# Decision following the hearing of a Plan Change to the Auckland Unitary Plan under the Resource Management Act 1991

## Proposed Private Plan Change 93 to the Auckland Unitary Plan

This plan change is **APPROVED** with modifications to that publicly notified. The reasons are set out below.

<b>Private Plan Change:</b>	Private Plan Change 93 - Warkworth South
<b>Applicants:</b>	KA Waimanawa Limited Partnership and Stepping Towards Far Limited
<b>Hearing commenced:</b>	Monday 4 November 2024
<b>Hearing panel:</b>	Karyn Kurzeja (Chairperson) Vaughan Smith David Mead
<b>Appearances:</b>	<u>For the Applicants:</u> Bill Loutit, Legal Rachel Abraham, Legal Lydia Chai, Legal Peter Cooney, Corporate Phillip Nicholson, Corporate Katie Dean, NZ Superfund Garth Falconer, Urban Design, Landscape & Visual Effects John Duthie, Planning David Hay, Planning Ian Smallburn, Planning Greg Akehurst, Economics Brendon Verhoeff, Engineering & Infrastructure Lucan Campbell, Engineering & Infrastructure Dr Matt Savage, Water & Wastewater Treatment Luiz Lobo Coutinho, Wetlands Polishing Philip Kelsey, Aquifer Treffery Barnett, Freshwater Ecology Chris Wedding, Terrestrial Ecology Todd Langwell, Traffic

IXXX.10.3 Waimanawa Precinct Plan 3 Transportation

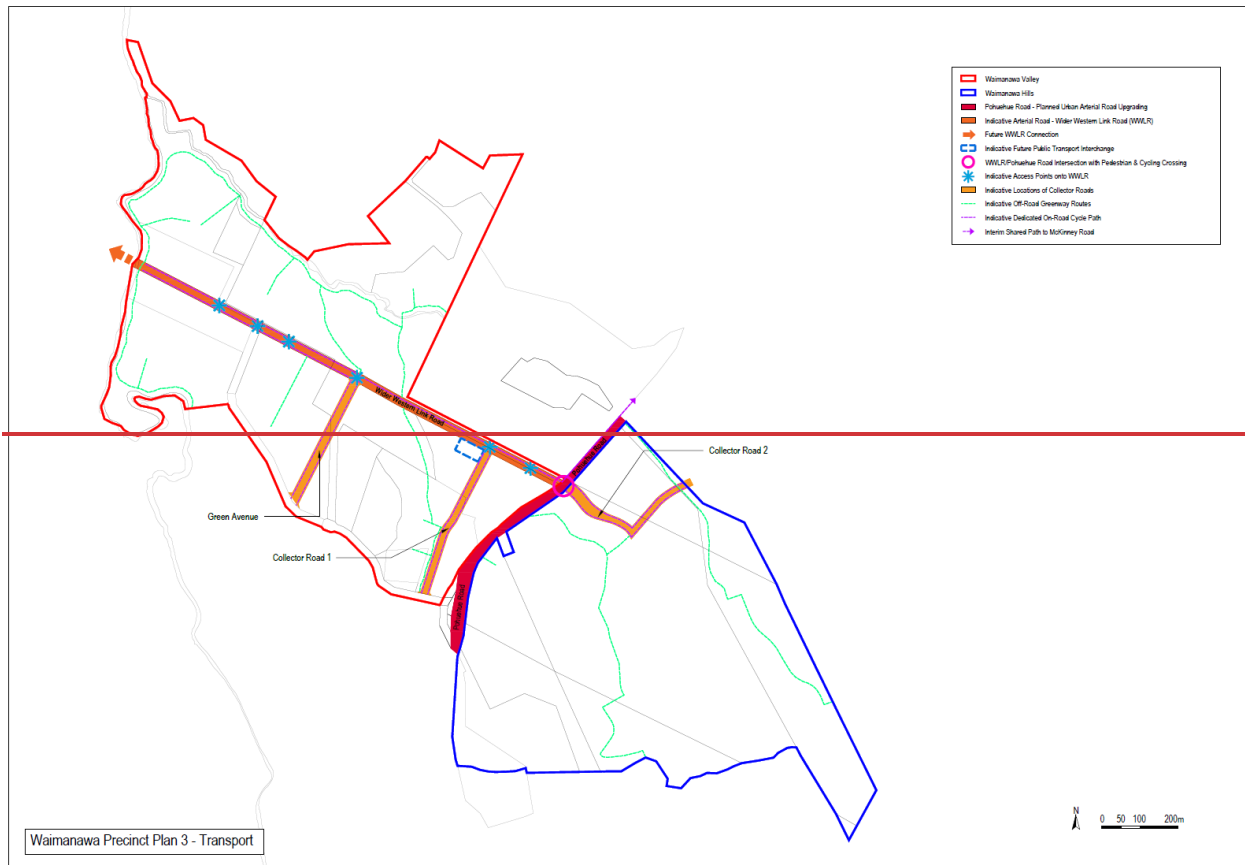
Road fronting the Large Lot Zone has been identified by a different symbol on Precinct Plan 3 (specifically an orange coloured dashed line), with reference provided to the appropriate standard, in the form of a note under Tables I593.6.15.1 and I593.6.15.2.

374. We also note that during the course of the hearing Mr Hay made an amendment to I593.10.3 Waimanawa Precinct Plan 3 Transportation to include a directional arrow showing a future WWLR connection, extending across the river to the Woodcocks Site from within PC 93. We understood that the WWLR connection aligns with the

#### IXXX.10.4 Waimanawa Precinct Plan 4 Indicative Open Space

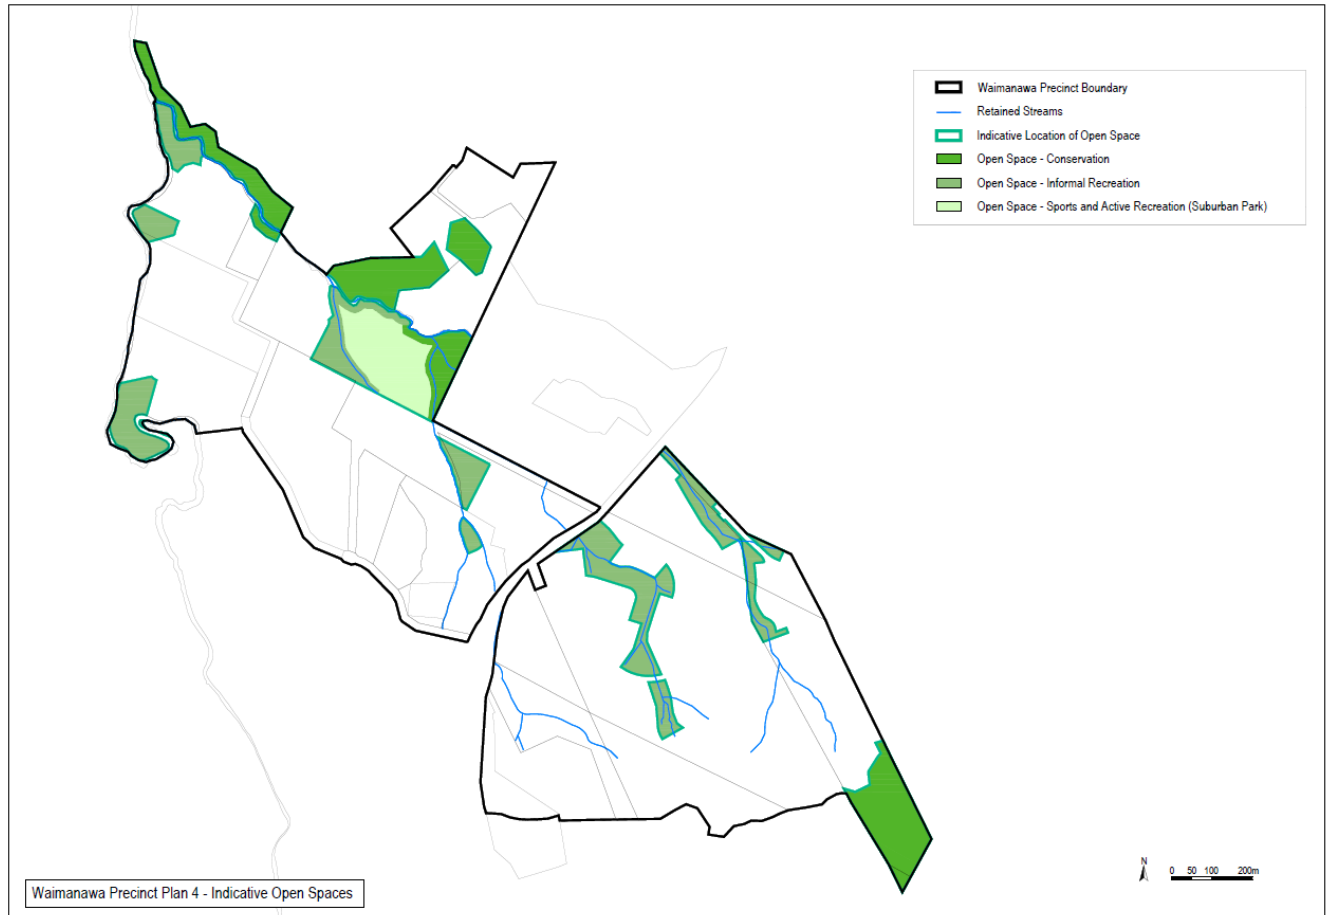
329. We are satisfied that the parks are clearly shown as indicative open spaces on Precinct Plan 4, and that the indicative space presented on Precinct Plan 4 is in the same general location as that shown on Figure 3 of the WSP. Mr Falconer has also demonstrated that a functional suburban park is feasible in the indicative location shown. Like all other greenfield development, the indicative parks will be subject to detailed assessment and design, which will include further consideration of both the
